RE: SYDNEY METRO CROWS NEST OVER STATION DEVELOPMENT (SSD 9579)

Concept Development Application (SSD 9579) for an OSD above the Crows Nest Metro station including maximum building envelopes, gross floor area, conceptual land uses, car spaces and signage zones

8.5. Crows Nest Over Station Development Amended Concept Plan

Source: Crows Nest - Over Station Development Appendix A - Architectural Drawings of Proposed OSD Building Envelope - DPIE 2020

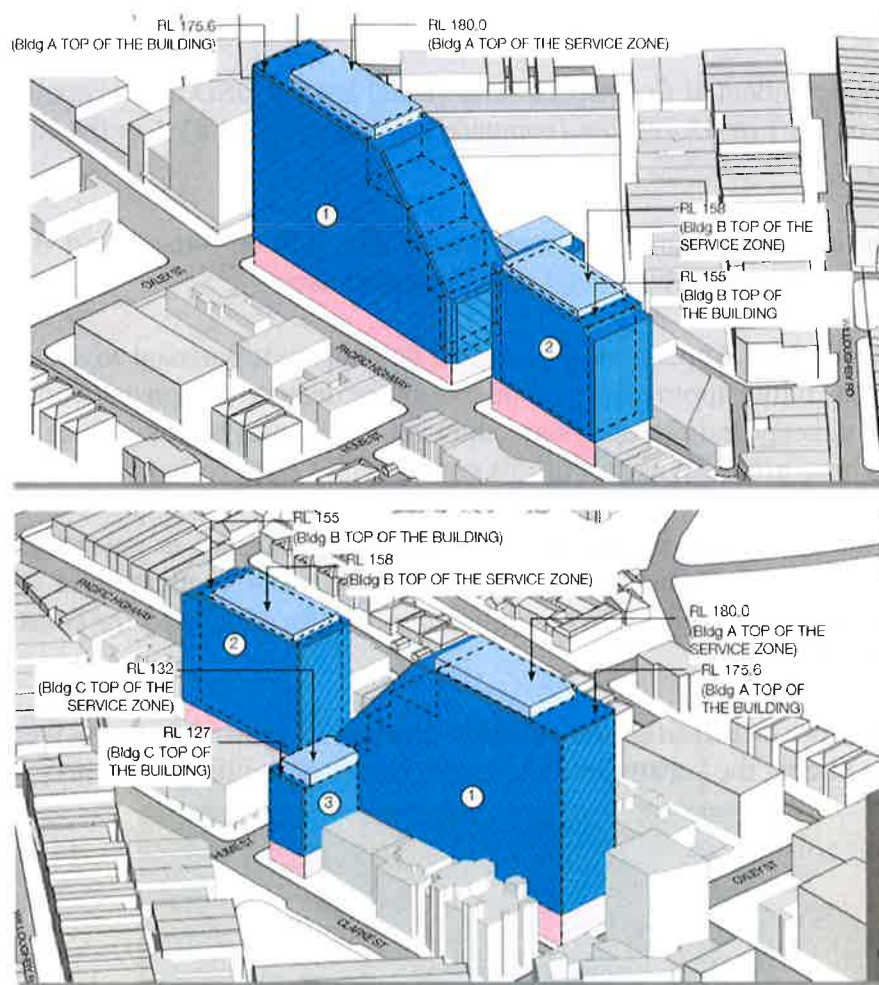
Then diagram below identifies the envelope changes as viewed from the west with the major change being the “chamfered” southern corner of building A (42m).

2.6 View and Visual Impacts

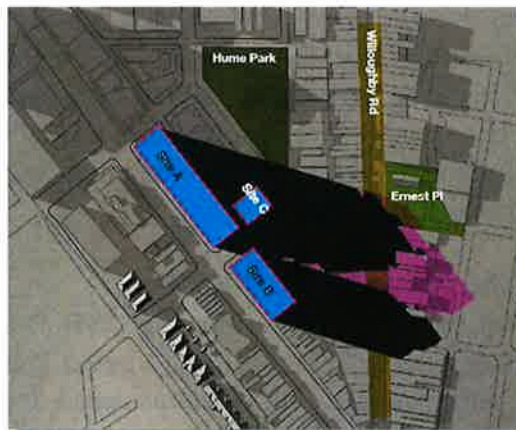
Council previously submitted that the representation of the visual impacts were somewhat misleading and that it was important to accurately reflect the significant impacts that would arise. DPIE agreed with the lack of accuracy. The visual impact studies have now been updated.

As has been well documented, the character of Crows Nest comprises low density, low scale development with a high degree of fine grain detailing and amenity. Whilst the architectural quality of a future development application will be relevant, the amended building envelope has a high propensity to be quite overbearing and potentially inconsistent with the highly valued character of Crows Nest. Further submissions will be made on this point.
